APPENDIX B
Responses to HDC comments, July 2016

Lutterworth East Development**Transport Input to Harborough District Council Comments****Executive Summary**

Lutterworth East Development
Technical Note on Updated Traffic Forecasting and Assessment

Figure 2.1 Wider Impacts – AM Peak Hour 2031

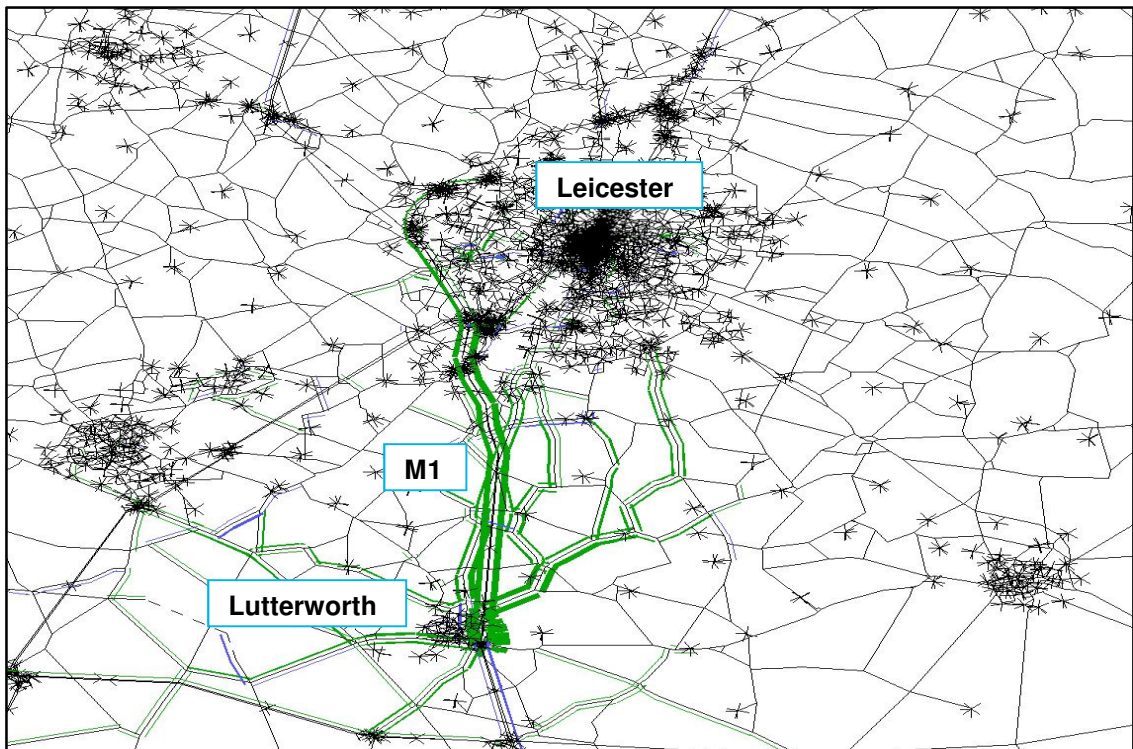
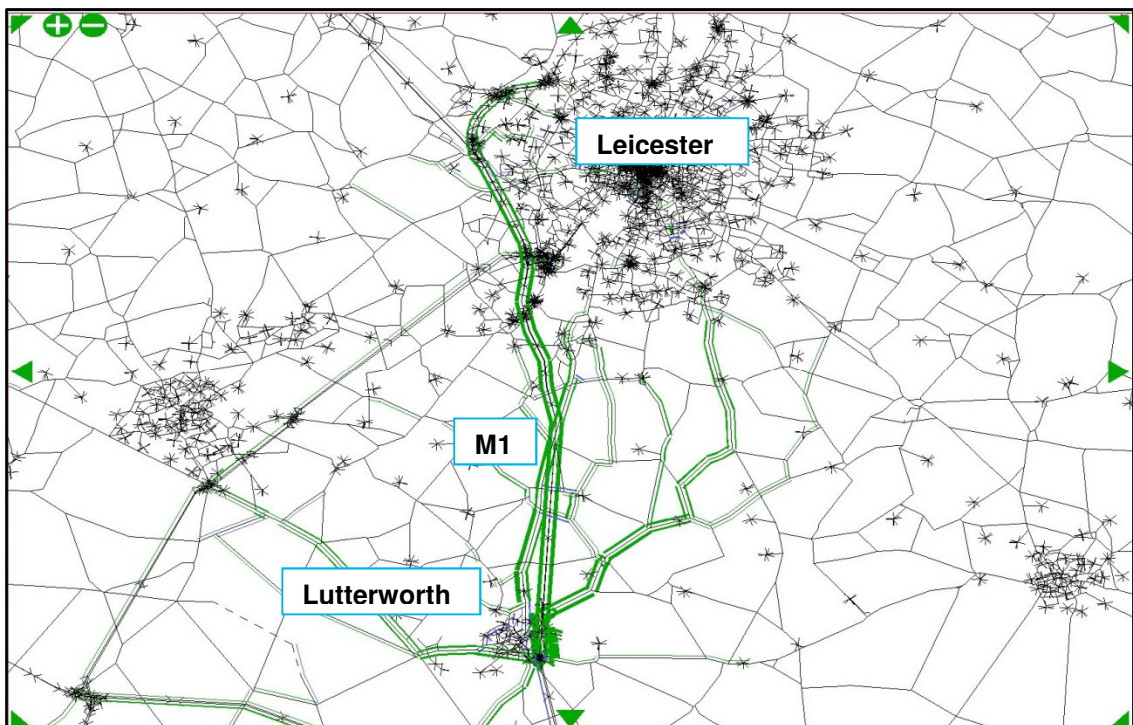
We understand that some initial work has been undertaken to identify the impact of the proposed SDA on the highway network including committed development. Further details on this would be useful in order for LCC to understand if this is sufficiently comprehensive, in particular has a wide enough study area been used? (For example is it necessary to consider any potential impact on M1 J21 to the north or the route to the M6 to the south?).

The wider impacts are summarised in **Figures 2.1 and 2.2** for the morning and evening peak hours respectively.

Figures 2.1 and 2.2 show the main impacts in the form of 'band widths' whereby the wider the 'band width' the greater the increase in traffic flow with development. The figures show increases:

- north of Lutterworth along the M1, A426 Leicester Road, on the route via Gilmorton village and A5199 Welford Road to south Leicester; and
- west along A4303 towards Magna Park.

Figure 3.1 Potential Through-Traffic Movements

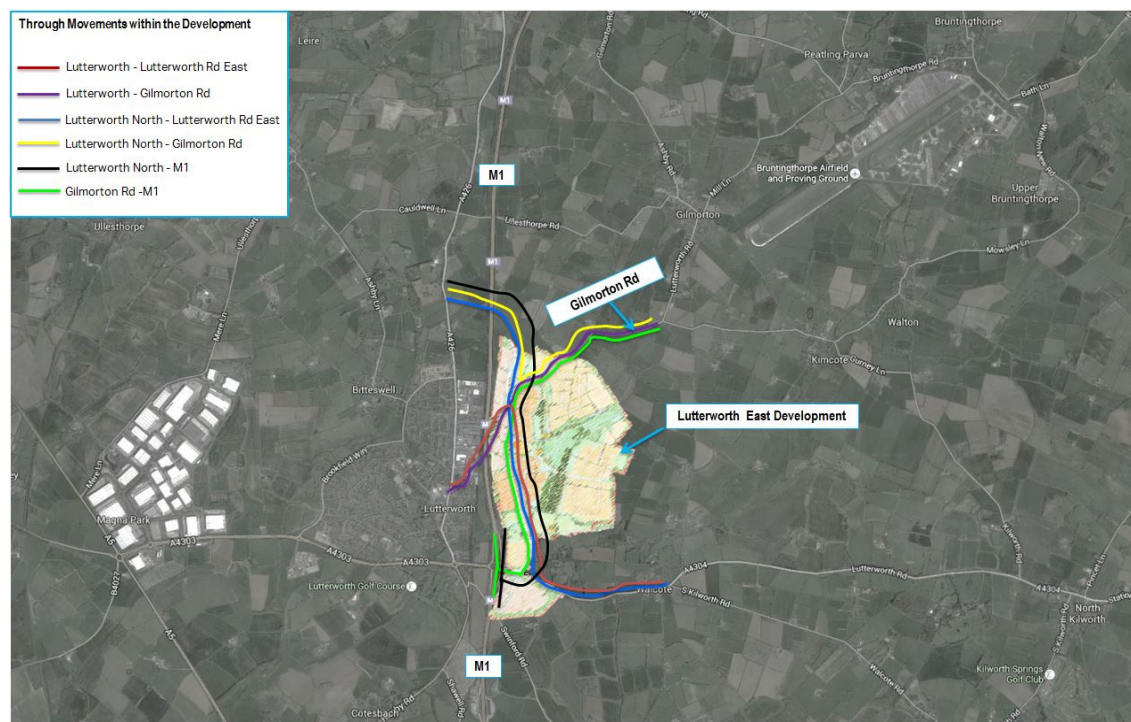
LCC note that proposals for mitigation include an alternative route to Lutterworth town centre in the form of a road through the development and that the associated benefits are intended to be improved air quality in the area, better access to town centre services and businesses with non town centre traffic using the new route through the SDA. At this stage LCC would like to understand further the role of the new road in the context of the local and strategic network, how it will interact with the existing road network and the broad design principles that will help it fulfil this role.

The primary purpose of the proposed Spine Road is to provide access for the development area to the south at A4304 Lutterworth Road and to the north at A426 Leicester Road. Its secondary purpose will be to provide alternatives for some Lutterworth town and Gilmorton Road traffic to use the new road to 'bypass' the town centre to access the M1 at Junction 20. In terms of the initial LLITM modelling, the model shows that with the full development of the Lutterworth East development and the Spine Road, that traffic volumes on A426 Leicester Road could reduce by around 10% when compared with the reference case forecasts without the development and Spine Road.

The potential through-traffic movements that may use the Spine Road are summarised in **Figure 3.1**.

It should, however, be noted that the Spine Road and its intermediate junctions have yet to be designed in detail. The proposed speed limit, design standard, junction configurations and method of control, together with the overall 'urban design' of the road within the context of the master plan development will influence its ability to attract and accommodate through-movements. The need for complementary measures within Lutterworth town such as a possible weight limit (to reduce HGV movements) on A426 Leicester Road and/or possible traffic calming (to reduce traffic) and/or bus priority measures (to encourage bus use) on Gilmorton Road may also need to be considered as the master plan and design of the Spine Road are further developed.

Figure 11: Frank Whittle and Indicative Travelodge Junctions Arrangement

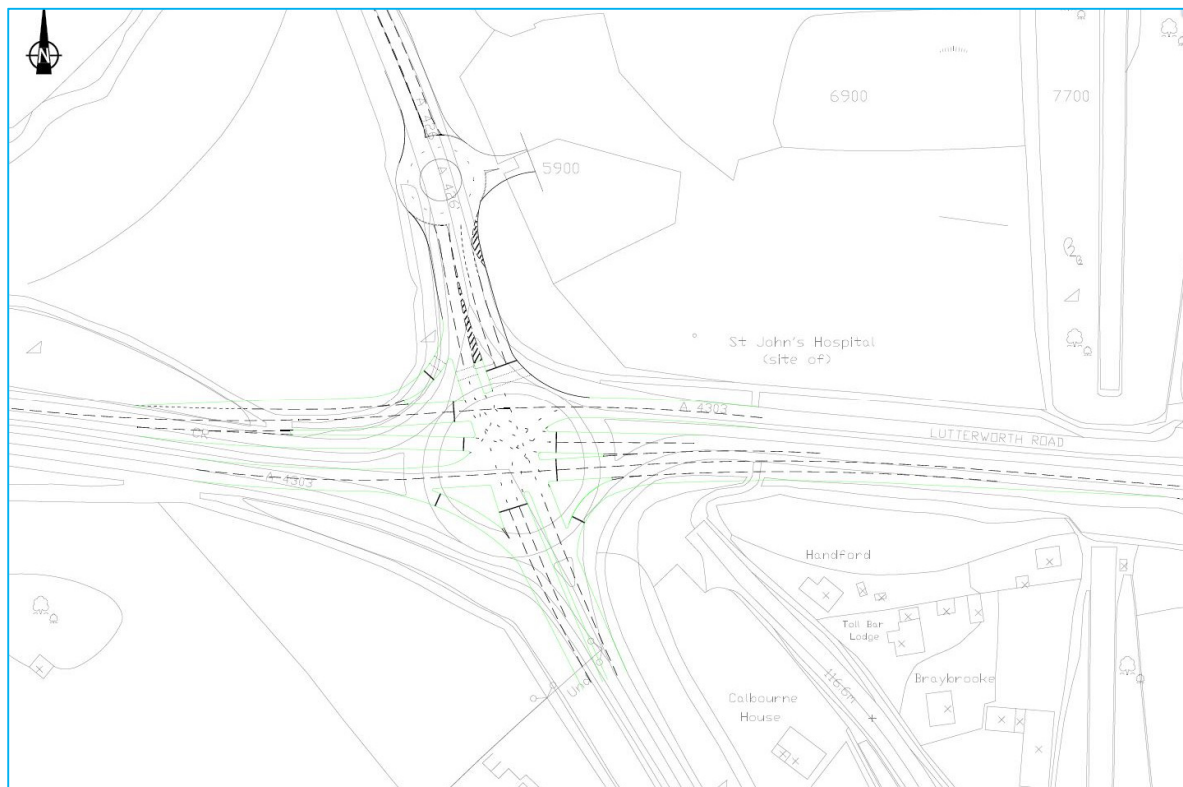
Due to the size and complex nature of this infrastructure and the early stage of the proposal, the highway authority would consider that there are some inherent significant unknowns/risks associated with its delivery. (e.g. land ownership, cost estimates, constraints, utilities, etc.) Whilst this is to be expected in the early stages and we note that the promoters will develop the proposals further and intend to deliver the key pieces of infrastructure it should be noted that the Highway Authority would not accept a s.106 agreement relating to this until further work to reduce risk has been undertaken.

As the Frank Whittle junction mitigated into a crossroads signalized junction, there was a need to provide a solution for the traffic heading to the development north of the Lutterworth Road (between Frank Whittle junction and M1 Junction 20). A new roundabout was provided with an ICD of 30 metre to accommodate the U-turn movement of the committed development, in addition to provide a right turn for the traffic heading out of the Travelodge arm. **Figure 11** shows the layout arrangement. The layout of the roundabout would be subject to further design considerations and investigation.
